DEVELOPMENT REVIEW COMMITTEE (DRC) COMMENT REPORT

PROJECT NAME: River Oaks

CASE NUMBER: R18077

REQUEST: Site Plan Level III Review: 13 Residential Cluster Units

Existing Stormwater Asset Map possibly affected by the Proposed Development

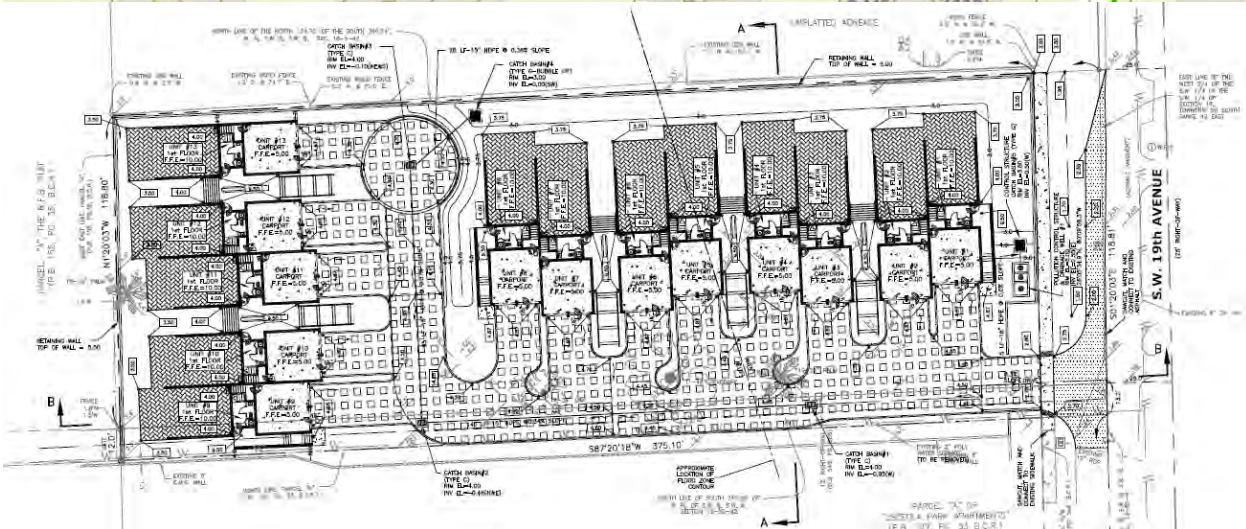
The City owns and maintains stormwater infrastructure adjacent to the proposed development as shown with green line work in the map provided at the end of this report. **Civil plans shall be revised to show the City's stormwater inlet ID #s as identified in the map provided at the end of this report.** The following comments pertain to possible impacts of the proposed development and/or construction activities to the existing condition of the City's stormwater assets. The applicant shall provide an itemized response letter addressing the following comments:

- a) Contractor shall provide CCTV videotapes to City STW OPS of the existing stormwater system to the limits shown with green line work in the storm map provided at the end of this report in order to document the PRE and POST construction conditions of the City's storm system.
